Re: Dockets 50-275-OL  
50-323-OL

SUBJECT      Diablo Canyon Nuclear Power Plant  
                 Physical Model of Thermal Discharge  
                 Telcon with NRC, October 28, 1975

## MEMORANDUM:

Figure III-17. AREA IN ACRES INFLUENCED BY ISOTHERM

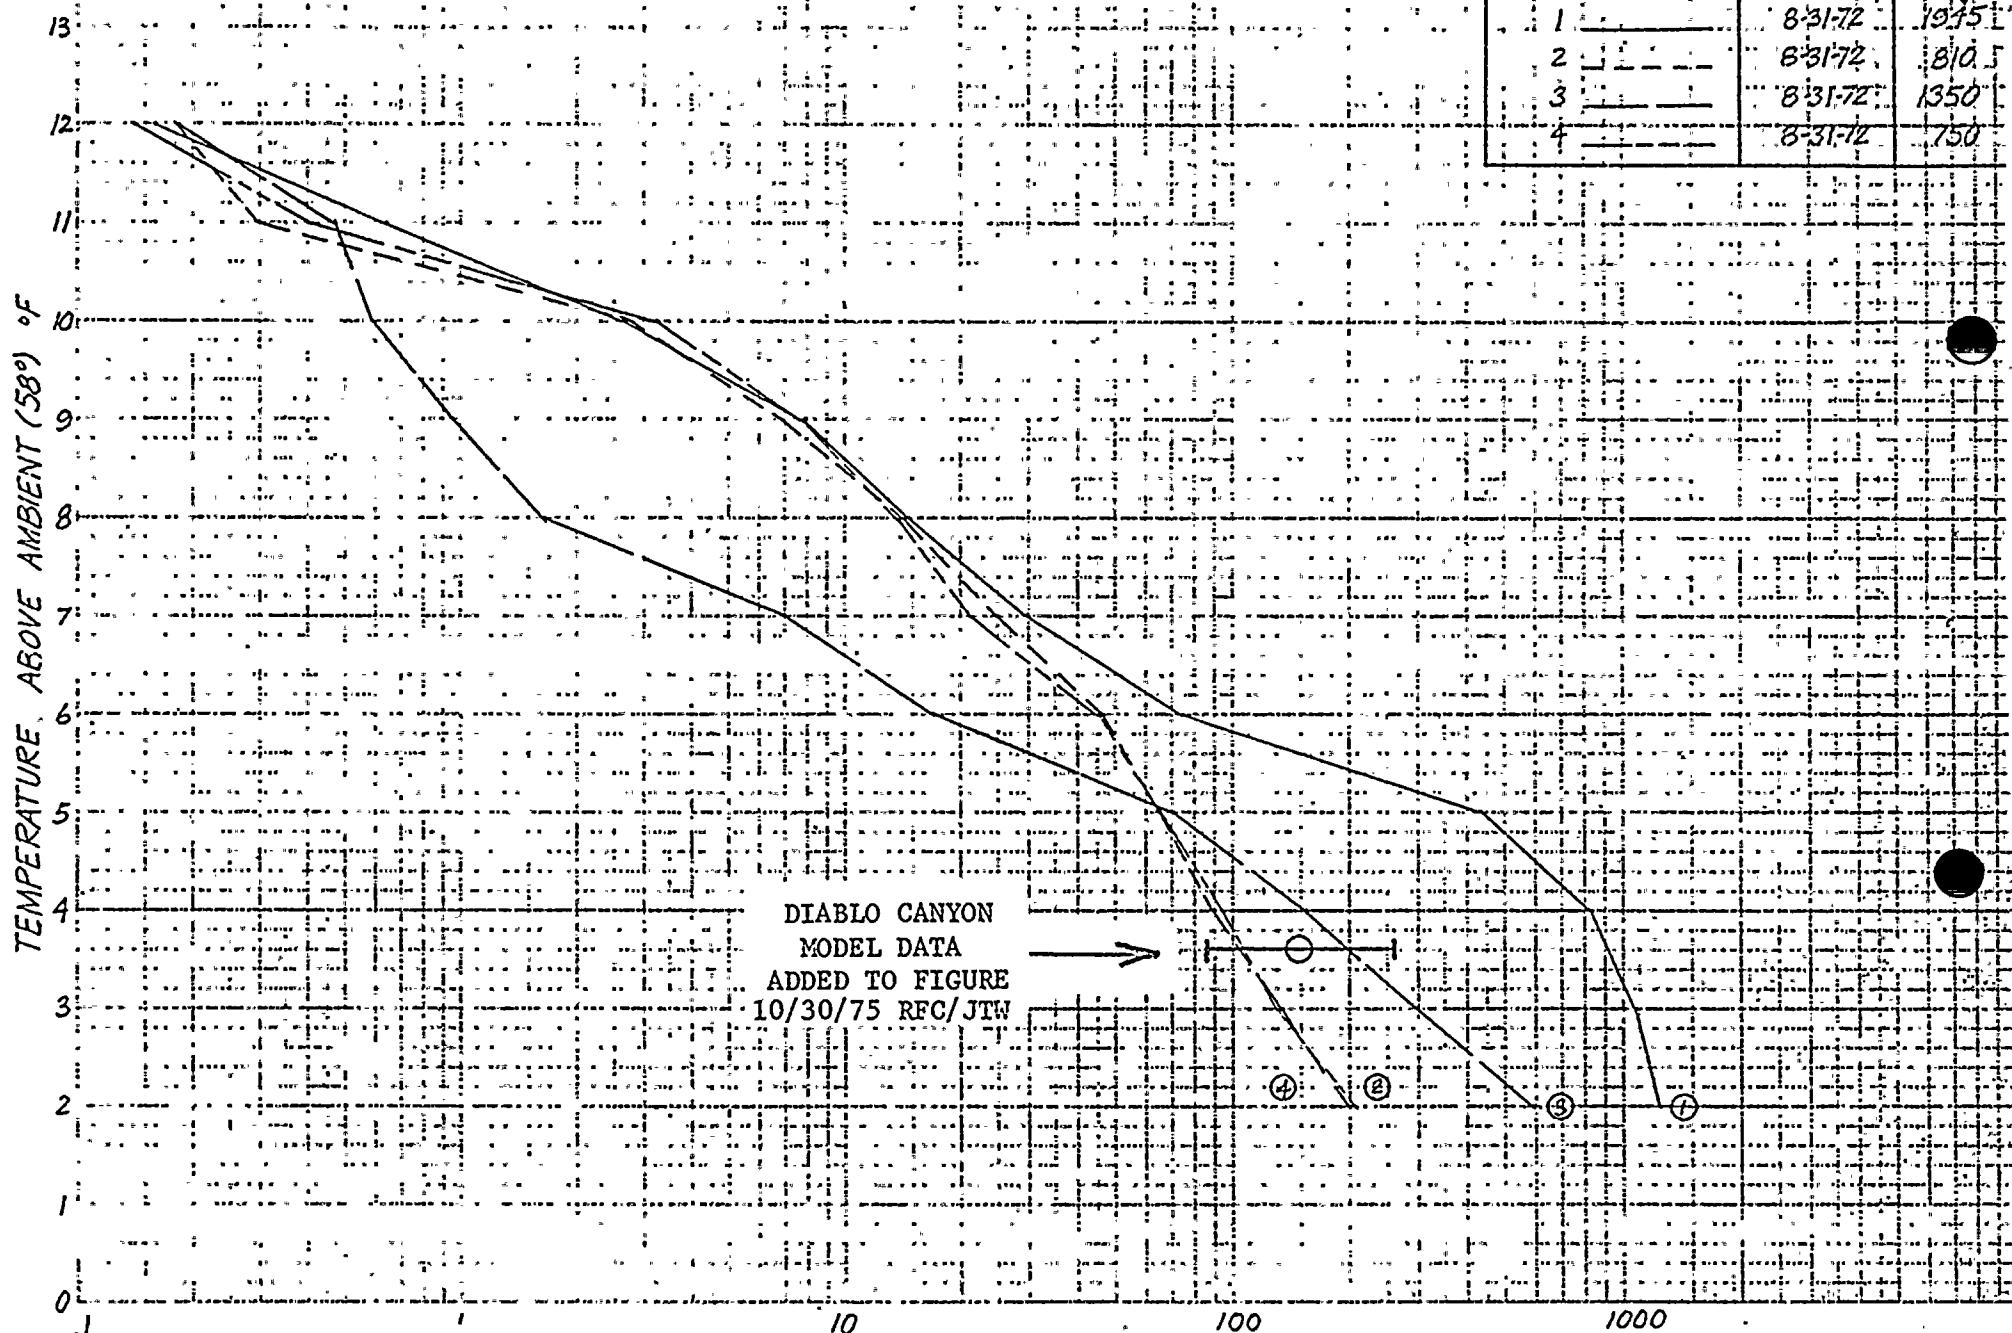
- c. Field studies done at Morro Bay Power Plant under a 1050 MW(e) load and a 19°F condenser temperature rise correlate with the model isotherm predictions. One result of these field studies, which were reported in An Evaluation of the Effect of Warm Water Discharges on the Beneficial Uses of Receiving Water, Morro Bay Power Plant, PGandE, 1973, was the enclosed figure showing the isotherm intensity versus areas enclosed by the isotherms. The range of several model predictions for a 2°C isotherm increment is shown there to fall within the range of Morro Bay field data. Although the Morro Bay discharge structure and flow velocity distribution near the structure are different than those of Diablo Canyon Power Plant, surface water temperature distributions well away from the structures should theoretically be similar so long as the waste heat load and condenser temperature rise are comparable. For that reason, the model agreement with Morro Bay field data at the 2°C isotherm locations is considered significant.
